CETHANA QUARRY

- Memo of J.R. Neall
To Planning Engineer.

13th October, 1967.

Comments on Memo:-

FIG. 1

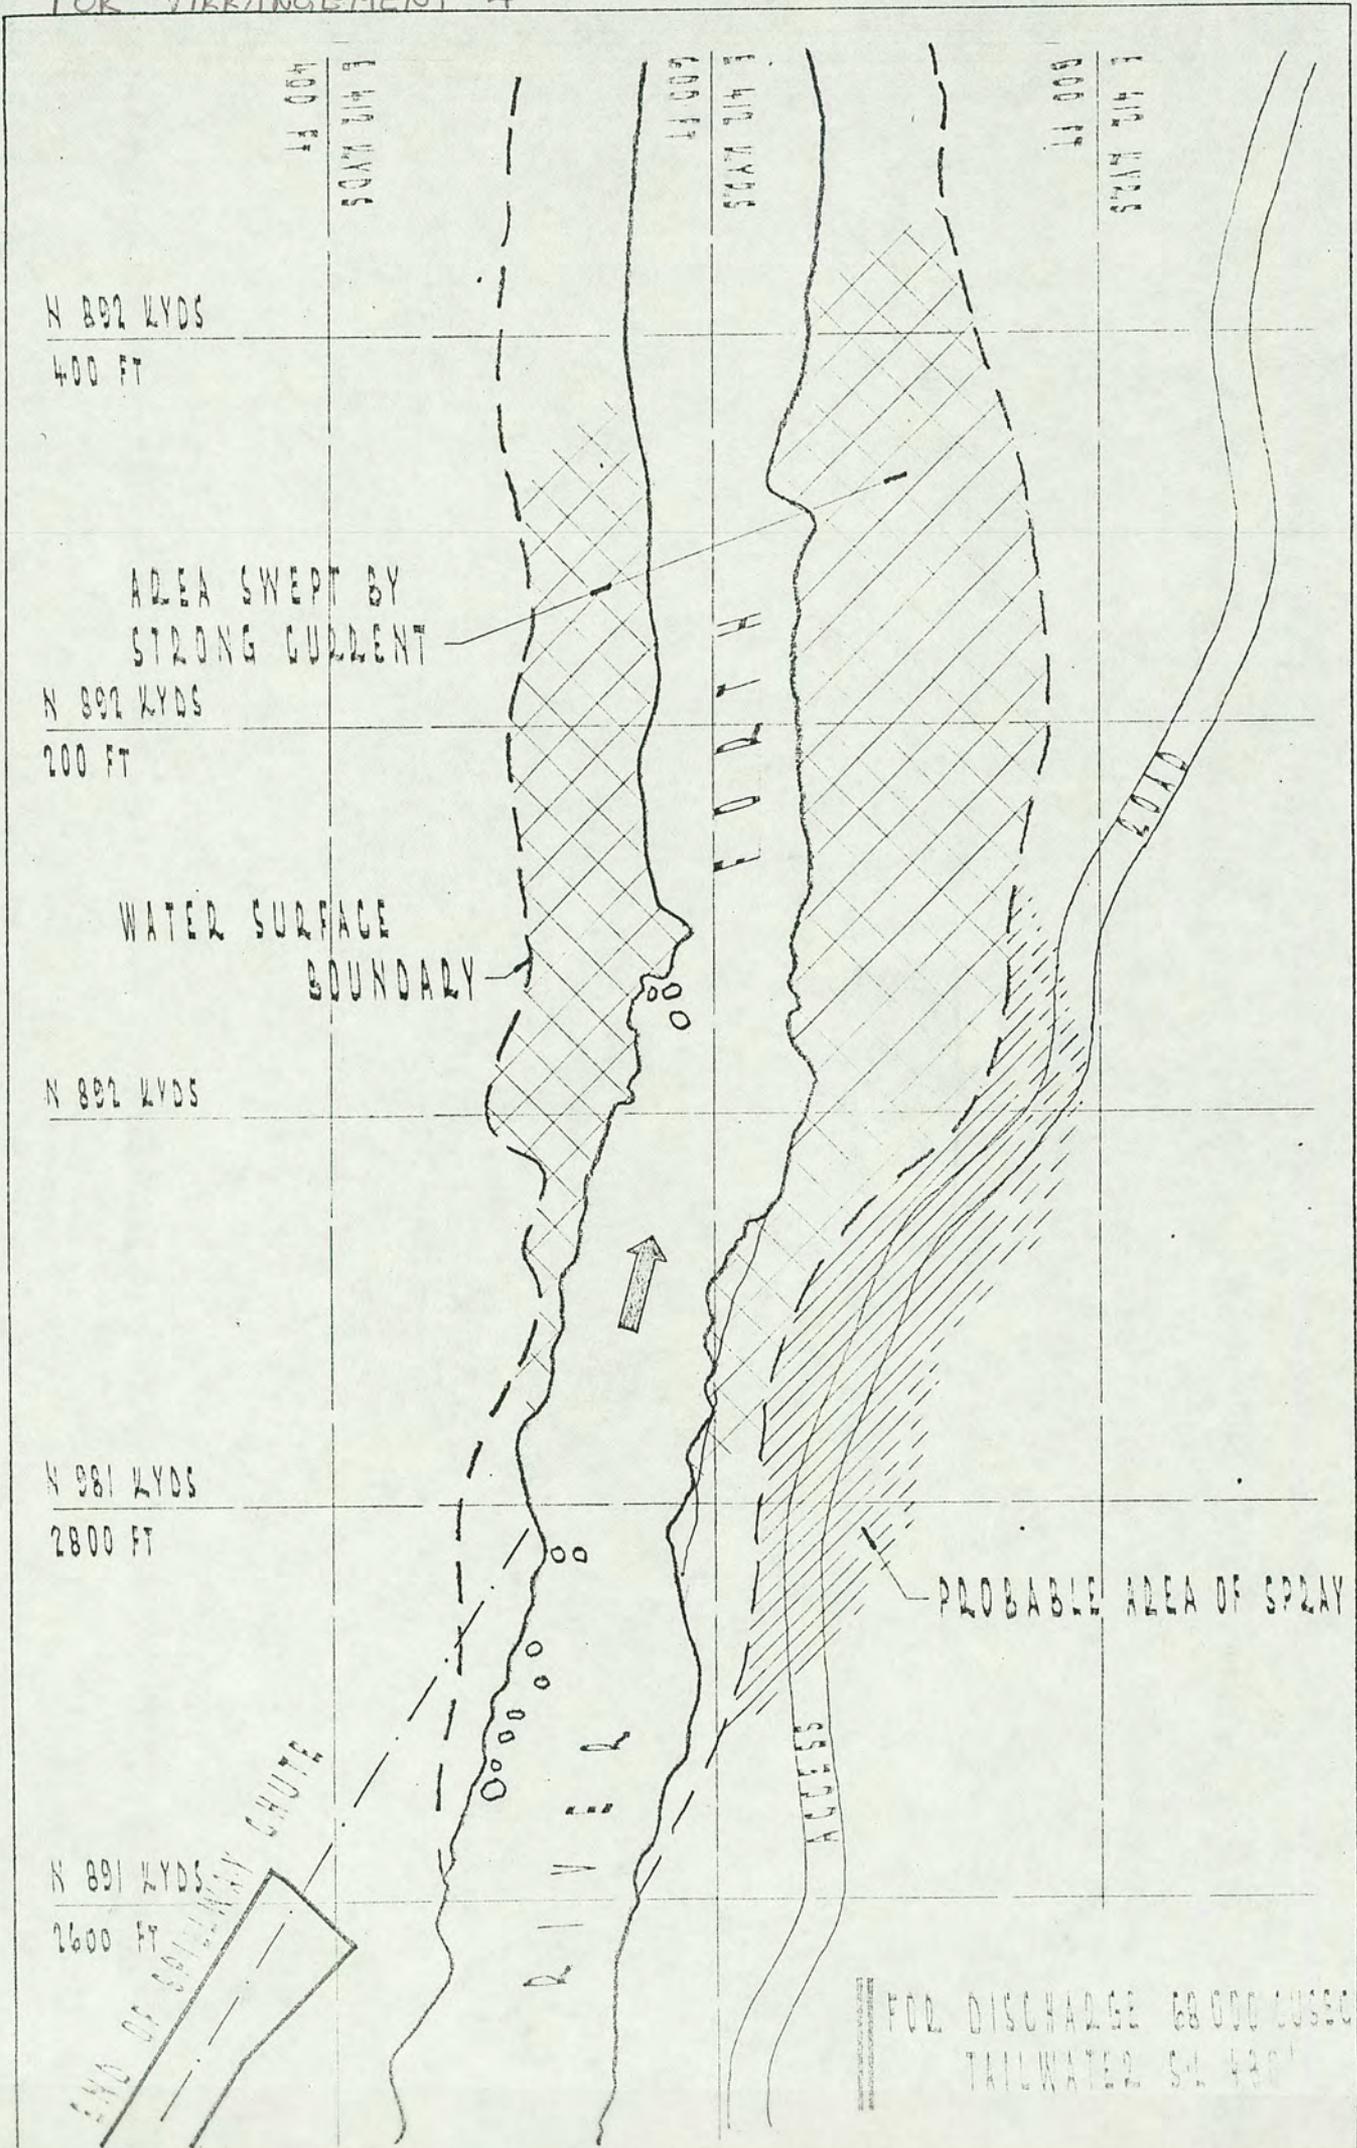
This is not clearly defined by the model studies because of surface tension effects. However, from a study of where drops of water did land in the model it would seem that the areas shown hatched on the accompanying Figure 2 could be thoroughly drenched by spray during the operation of the spillway at high discharges. No installations susceptible to moisture should be placed in this area. Attention should be given also to providing first class drainage of the access road in this area.

The water from the jet after impact sweeps up on the right bank for considerable distance downstream. All loose material should be removed from this area to prevent its accumulation in the river valley further downstream. The area that should be cleared is shown in Figure 2 crosshatched.

Sluicing of the area shown on Figure 2 crosshatched should be done down to the end of the river improvements.

To Accompany:	THE HYDRO-ELECTRIC COMMISSION, TASMANIA				SCALE	A14659
Ref. Drawg.	MERSEY-FORTH POWER DEVELOPMENT				1:40	
CETHANA SCHEME QUARRY		Drawn by	Traced by	Checked by	Geologist in Charge	
		by

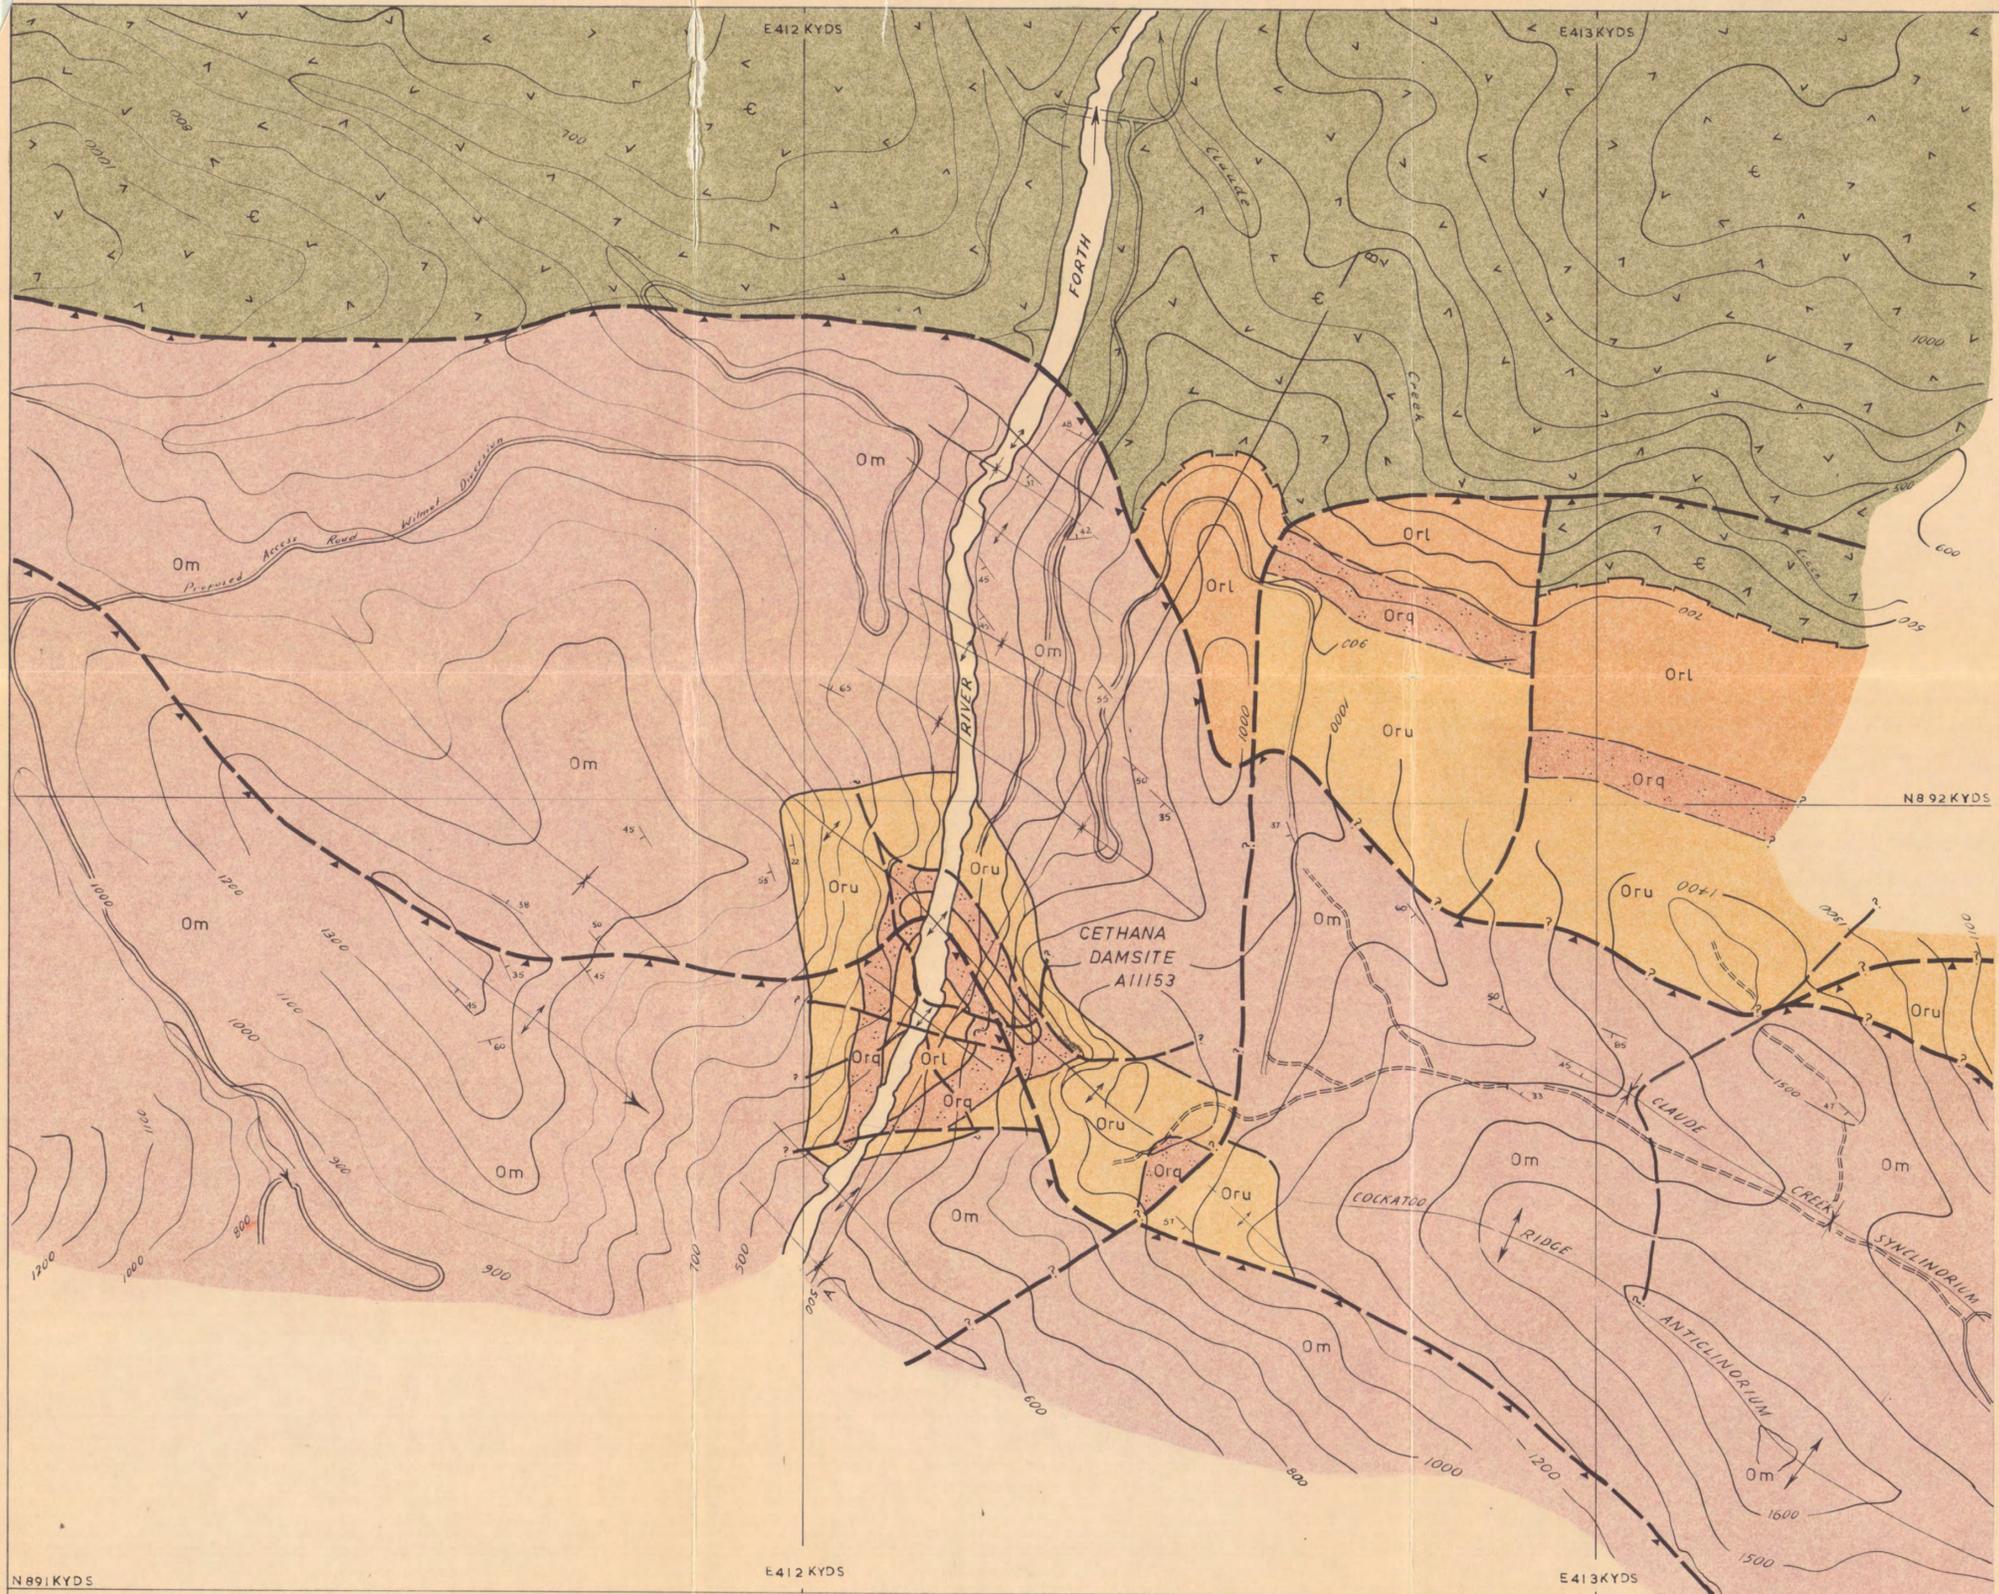
1. Para 2 sub-paras (a) to (d) are agreed with.
2. The upper bench levels at the North Westerly end of the quarry from the NW (haulage road entrance) quarry limit to about 700' to the South East lie within series 2 and 3 rocks of varying quality.

At 80' from the NW quarry limit, all of bench level 815' is composed of series 2 and 3 rocks. About $\frac{3}{4}$ of bench level 780' and $\frac{1}{2}$ of the 745' bench level are also composed of series 2 and 3 rocks.

At 340' from the NW quarry limit, all of bench level 815' and upwards should lie in series 2 and 3 rocks with $\frac{2}{3}$ of the 780' bench level and $\frac{1}{3}$ of 745' bench level in the same sequence.

At around 720' from the North West haulage entrance end of the quarry limits, the quarry, apart from about half of bench level 885', lies within acceptable series 4 quartzites and the bottom conglomerates. Thus, to this point, the limit of acceptable rock transgresses the bench levels obliquely in a South Easterly direction from about 400' from the North West quarry limit.

At about 950', 2/3 of the 885' bench level lies within series 3 rocks, none of which, here, appears suitable for use.

The 850' and 815' bench levels in this area, also show up on the quarry plan as lying partly within series 3 rock. However, due to the Northerly dip of the beds and the depths of the benches in relation to the boundary of the acceptable rock, only about 1/4 of the 850' bench level and none at all of the 815' bench level should include unacceptable series 3 rocks.

3. The South Westerly assumed limit of good rock on the quarry plan, lies from 30' to 50' to the South West of the limit of good rock as based on surface mapping.

An area of roughly 75' by 250' of the 675' bench level lies within Cambrian quartzites and also 50' x 280' of the 640' bench level and 25' x 380' of the 605' bench level.

1. 300' hole to be drilled from the site of D.H. 5515 in a direction 220° at 60° angle to ascertain the quality of the Series 4-8 quartzite and the conglomerate (see attached plan). x
2. 100' hole at E412.0317/N890.2882 to investigate the quality of the quartzite close to the granite contact.
3. 400' hole at E412.1277/N890.2590 in a direction 200° at 60° angle to investigate the quality of the Series 4-8 quartzite and the conglomerate in view of the possible E. extension of the quarry. x
4. 300' vertical hole at E412.106⁵/N890.2376 to investigate the S.E. part of the possible E extension.
5. A further 100' angled hole sited to investigate the series 3 quartzite to allow for a possible N.E. widening of the quarry.
